**From:** [Pat Womack](#)  
**To:** "Garza, Johnnie"; [Misti Schulz](#)  
**Cc:** [Lissak, Matt](#); [Adam Boatright](#); [Kamie Fitzgerald](#)  
**Subject:** RE: Taylor - Williamson County Transportation Plan  
**Date:** Wednesday, July 8, 2026 10:19:00 AM  
**Attachments:** [image002.png](#)  
[image003.png](#)  
[image004.png](#)

Thank you for taking my phone call. Attached is a markup showing the property we're developing in Taylor, TX, overlaid on the Williamson County LRTP Amended Mapbook.

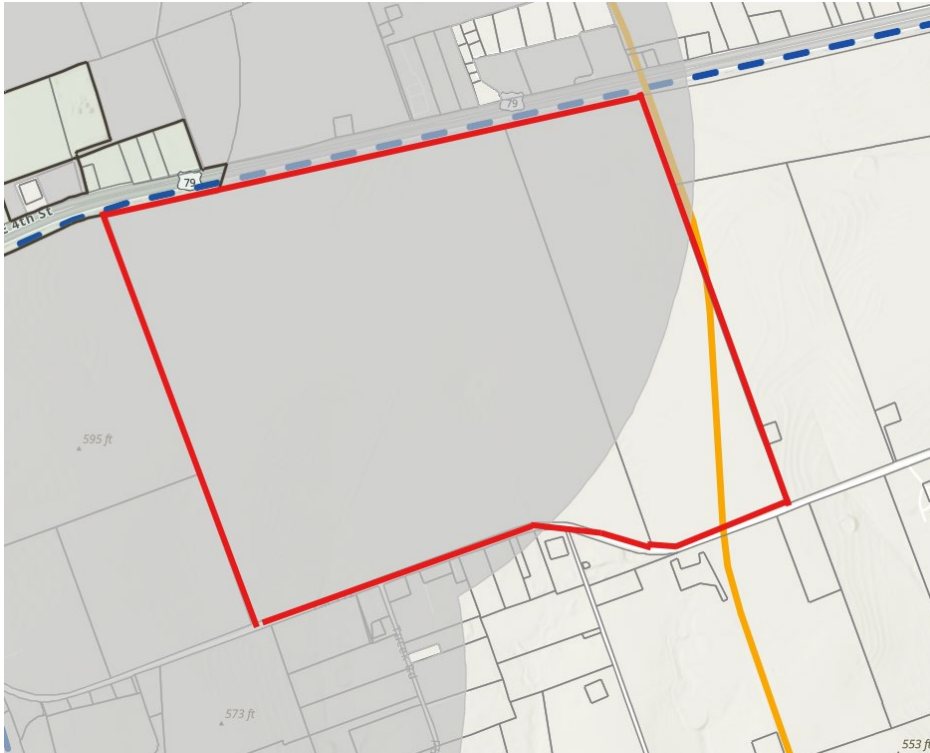
2. Is there any flexibility within the LRTP regarding roadway alignments? Since we're already proposing and dedicating a roadway along the west side of the property (pink line shown on the exhibit), we're hoping to understand whether there is any opportunity to align both thoroughfare plans.

Wilco LRTP Amended Mapbook

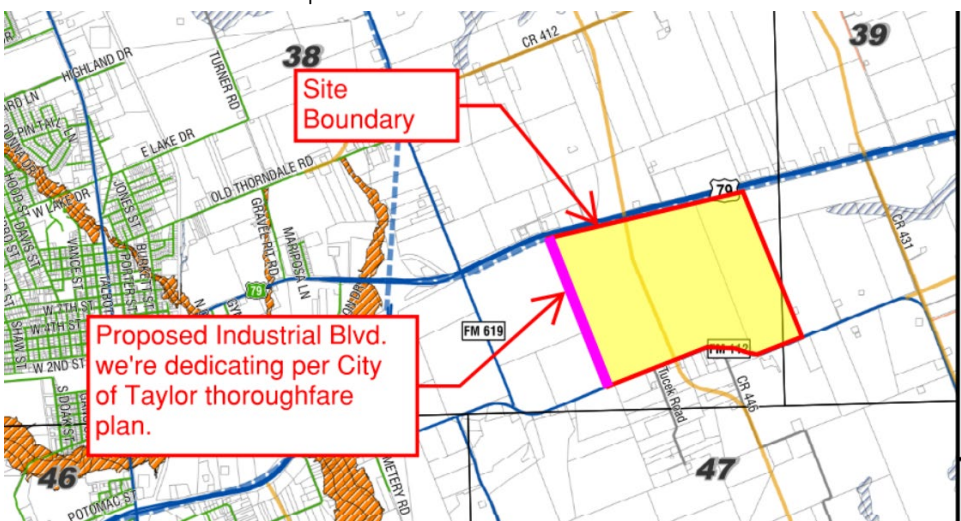
1. Is the LRTP Amended Mapbook the current transportation planning document for Williamson County? I assume it is since it is an amendment, but I wanted to confirm. The City of Taylor GIS map does not appear to align with the amended mapbook, and I want to make sure we're
